## Referral Responses – RFI (August 2022) Plans – 272-280 Normanby Rd, SM – C207port

<p><b>City Strategy</b> Gareth Nevin</p>	<p><b>05-09-2022</b></p> <p><b>CITY STRATEGY TEAM REFERRAL ADVICE</b></p> <p>Prepared August 2022 by Gareth Nevin - Senior Precinct Planner - Fishermans Bend</p> <p><b>I. REFERRAL REVIEW SCOPE</b></p>

- Proposed section 20(4) Amendment to the Port Phillip Planning Scheme (C207port)
- 272-280 Normanby Road, South Melbourne
- Associated Johnson Street Park Road Closure (Work-in-kind opportunity)

- The images below compare architectural plans submitted for the previous approval C177port (left image) and the proposed modification C207port (right image).

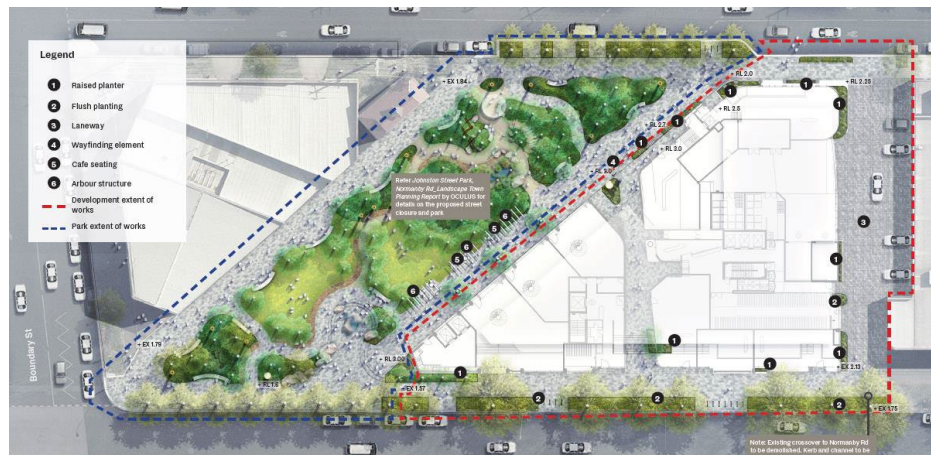
- The new façade strategy represents an improved design outcome for the site in comparison to the original approval.
- The façade strategy incorporates better use of materials – with a mixture of brick, metal and cladding in earth tone materials that align with the industrialized character of Montague Precinct.
- The ground floor frontages are well activated and weather protection canopies are provided over footpath areas.
- The façade strategy provides a clear distinction between podium and tower, and highlights differentiations between residential and non-residential land uses.

- The proposed tower forms appear overly 'flattened'. The design should provide improved definition and articulation with, for example, cohesive use of openings, balconies, solar and wind mitigation elements, deep reveals and blocking elements.
- Footpath trading areas should be designed in accordance with Council's Footpath trading guidelines on Normanby and Munro Street. A unique design (as proposed) may be supportable at the Johnson Street park frontage.

**Comments - Communal Open Space:**

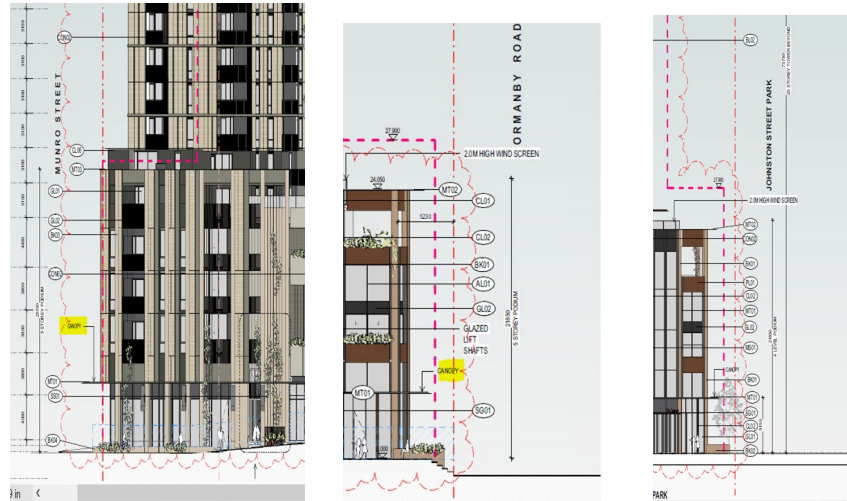
- Clause 58.03-2 (Apartment Development Communal Open Space Objective) Standard D7 requires a minimum 220 sqm of communal open space.
- The original approval provided 1,171 sqm. The new application seeks a reduced size of 640.5 sqm. While it is acknowledged that the reduced size exceeds minimum requirements, it is not preferable. Recommend exploring options to increase the size where practical within the confinements of the rooftop.
- The podium level contains a passive green space with mounded lawn, garden beds and decking. The updated rooftop space has been designed with a multitude of uses on the rooftop level, described as including plunge pools, a fire pit, boardwalk, a

dining booths, food preparation and BBQ area, deep planting areas and vegetable gardens. From a strategic planning perspective, the multitude and variety of functional spaces within this layout is generally supported, subject to meeting wind comfort requirements, and any urban design/landscape requirements provided by other areas of Council.

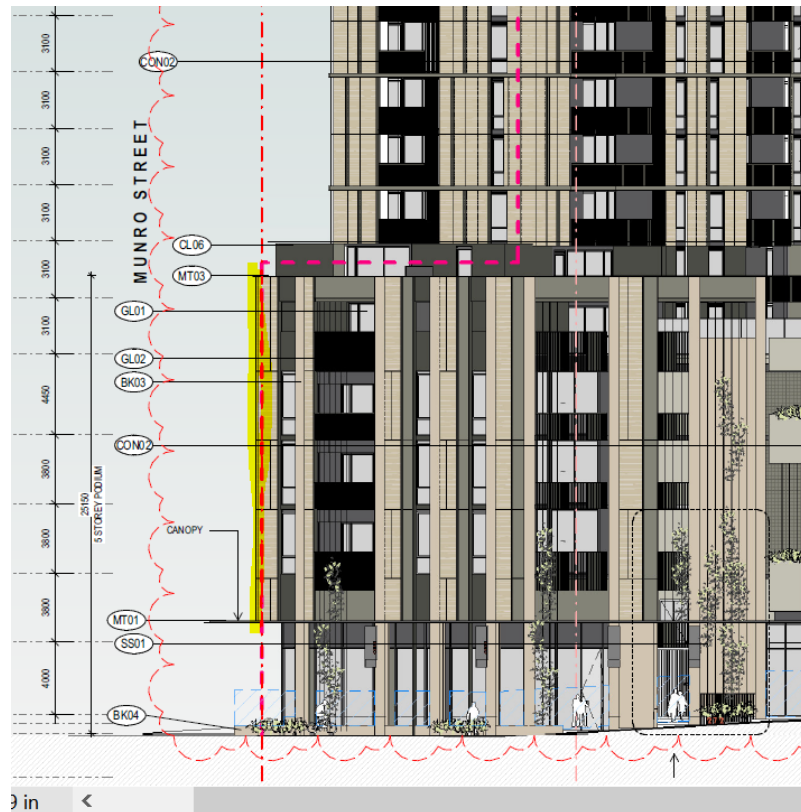
- From a drainage perspective, as the water falling on the proposed canopy highlighted below can drip on the pedestrians which can cause a nuisance, hence, water falling on these features need to be captured and conveyed to the legal point of discharge.

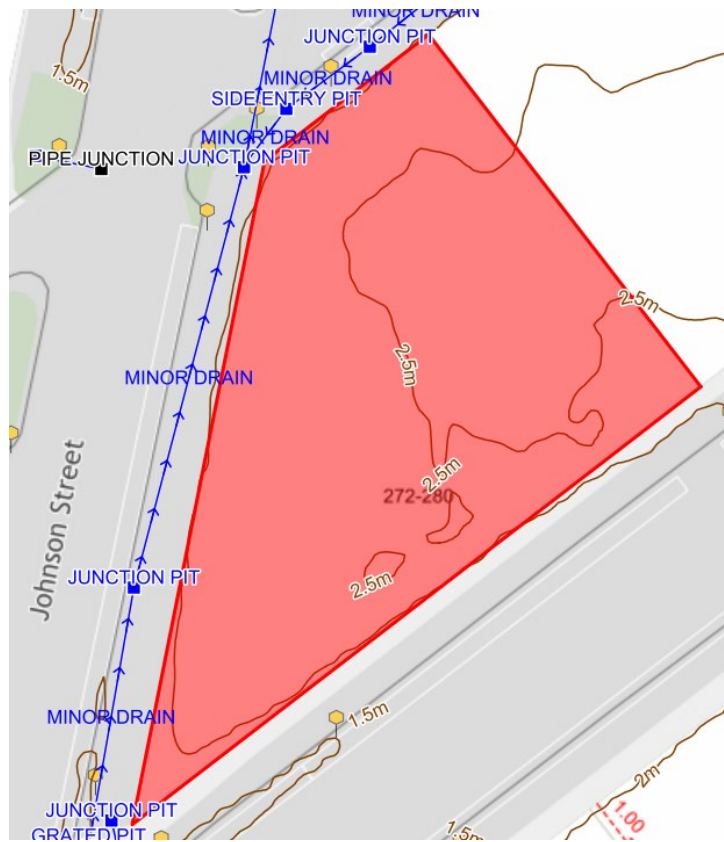
- Any wall projection highlighted below should not encroach onto the public realm and be constructed within the property boundary.

- Any proposed on-ground facilities (seating arrangement, arbour etc) not to obstruct the existing stormwater pits along Johnson Street. Pits to be made accessible for future maintenance and replacement of pipe/pits.

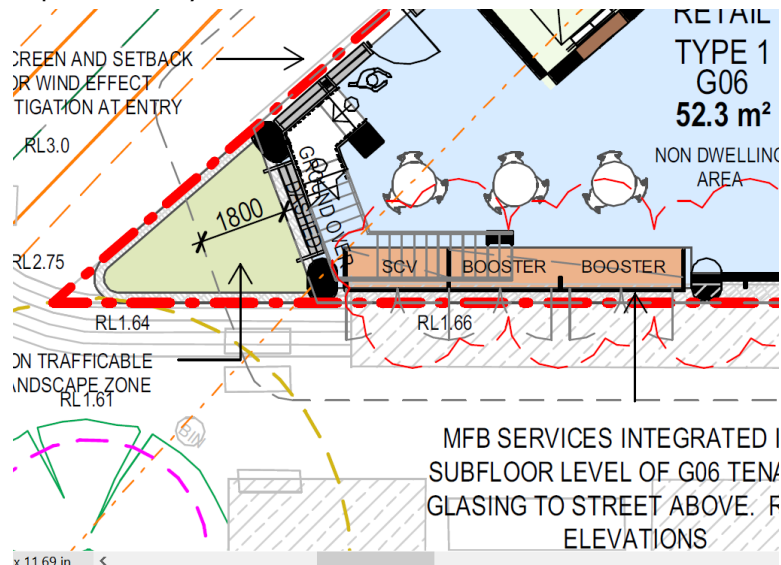
- Access doors to the services (SCV, Boosters) shown below are required to be:
  - o Self-closing and can be held fully open against the building wall for the time personnel are occupying the facility;
  - o In the fully open position do not encroach more than 100mm into the Road Reserve;
  - o Have a minimum clearance of 150mm from the footpath surface;
  - o Open onto a footpath with a minimum width of 1500mm.
  - o The doors must be kept locked when not in use with the keys made available to approved personnel only
